ADDENDUM NO. 5

DATE: April 21, 2020

FROM: Baxter & Woodman, Inc., Consulting Engineers

VILLAGE OF HOFFMAN ESTATES, ILLINOIS  
GOLF ROAD LIFT STATION REPLACEMENT

NO SCALE

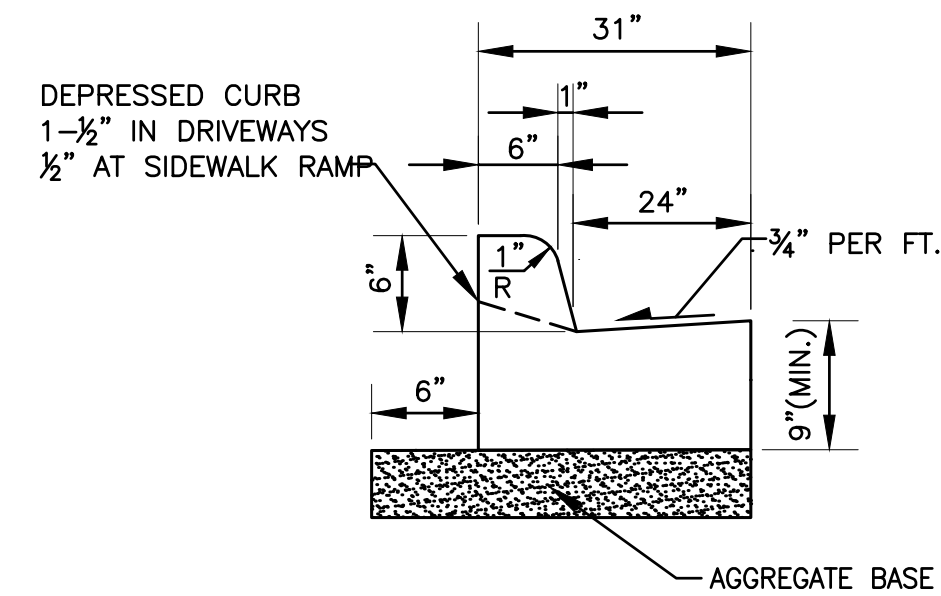
- A. Delete Sheet C-1 in its entirety, and insert attached Sheet M-1, revision dated April 21, 2020 in lieu thereof.
- B. Delete Sheet C-5 in its entirety, and insert attached Sheet M-1, revision dated April 21, 2020 in lieu thereof.
- C. Delete Sheet M-1 in its entirety, and insert attached Sheet M-1, revision dated April 21, 2020 in lieu thereof.
- D. Delete Sheet M-3 in its entirety, and insert attached Sheet M-1, revision dated April 21, 2020 in lieu thereof.
- E. Delete Sheet E-3 in its entirety, and insert attached Sheet M-1, revision dated April 21, 2020 in lieu thereof.
- F. Delete Sheet E-4 in its entirety, and insert attached Sheet M-1, revision dated April 21, 2020 in lieu thereof.
